Folder [Drybasin progress report 20240701]

Report on first rain event during construction of Drybasin

This is an initial report following the first reasonable rainfall event after the weir pipe has been installed at Williamson.

20240630_085241_001.jpg

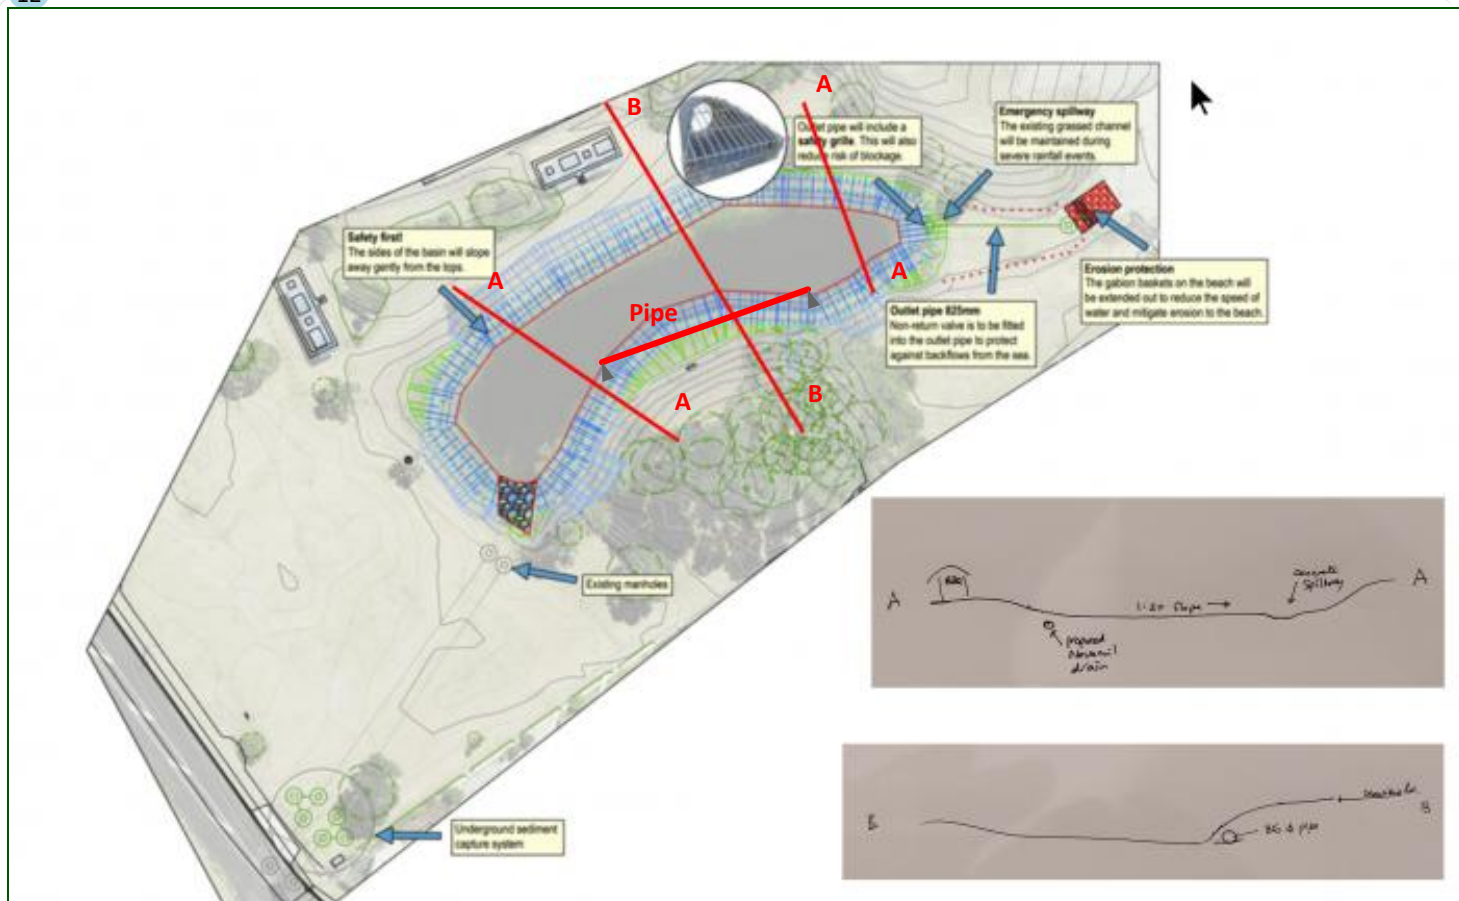
Water table now above the line of rocks.
